Exhibit 1

To: PacifiCorp 2011 Integrated Resource Plan Team
From: Sierra Club
Date: March 8, 2011
Re: Comments on Public Input Meetings 6 & 7, Jan 31 and Feb 23, 2011

To: PacifiCorp 2011 Integrated Resource Plan Team
From: Sierra Club
Date: March 24, 2011
Re: Comments on Draft 2011 Integrated Resource Plan

The 20-yr capacity additions, as shown in the “Portfolio Development Results” presentation from January 28, 2011, are shown in the figure below.

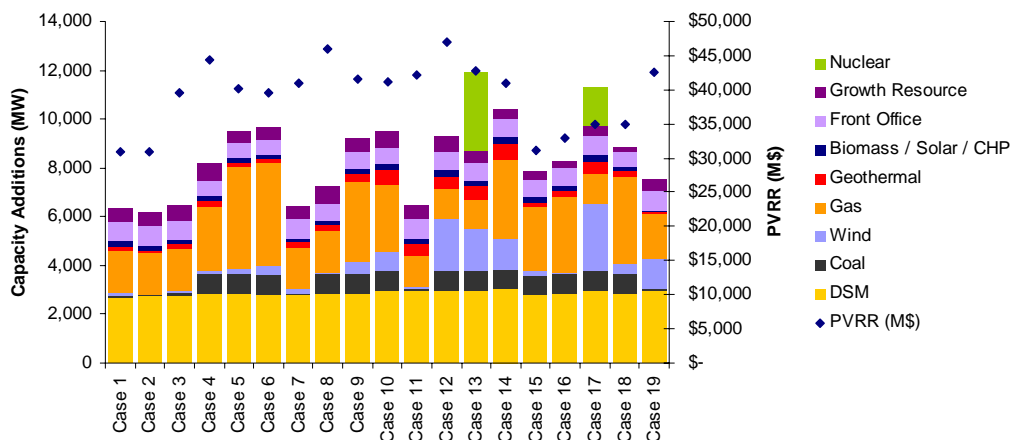
Indeed, the portfolios presented to stakeholders show extremely consistent results: a fixed amount of DSM made available in each core scenario (over 20 years, ~1,300 - ~1,500 MW in the

East and ~1,250 MW in the West),³ little geothermal in near-term years, gas to meet capacity requirements in the near term, and variable amounts of wind in the longer-term. Most of the coal and nuclear additions only occur in the model in year 2030, neither substantively impacting model results nor the net present value.⁴ The results are convoluted by the ambiguous “front office transactions” and “growth resources”, which have undefined cost, energy implications, or emissions.

4. PacifiCorp should include all (51) runs, including sensitivities, in net present value calculations and evaluation criteria for preferred resource plan;
5. PacifiCorp should test alternate DSM availability criteria, assuming economic potential (i.e. utility test cost-benefit) in full resource territory;
6. PacifiCorp should provide and evaluate information on the external environmental and economic consequences of given portfolios.

What these development scenarios do *not* show are the unchanging portfolios underlying the new capacity additions, now added into in the figure below.

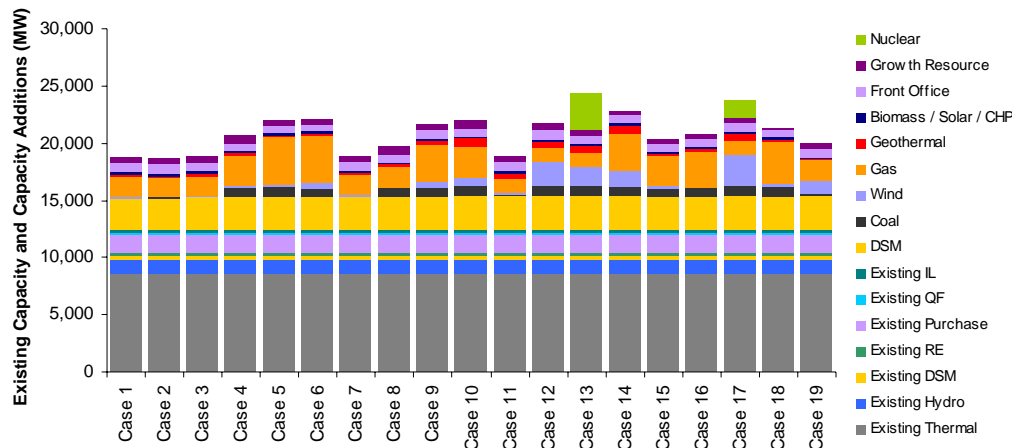
By having left these resources intact in the only considered scenario runs, and not evaluating the forward-going costs of operating existing units on an economic basis, the Company needlessly exposes ratepayers to unnecessary financial and regulatory risk, such as required improved environmental controls on existing coal plants, a price on greenhouse gas emissions, and rising coal prices, all of which expose ratepayers in the existing fleet.
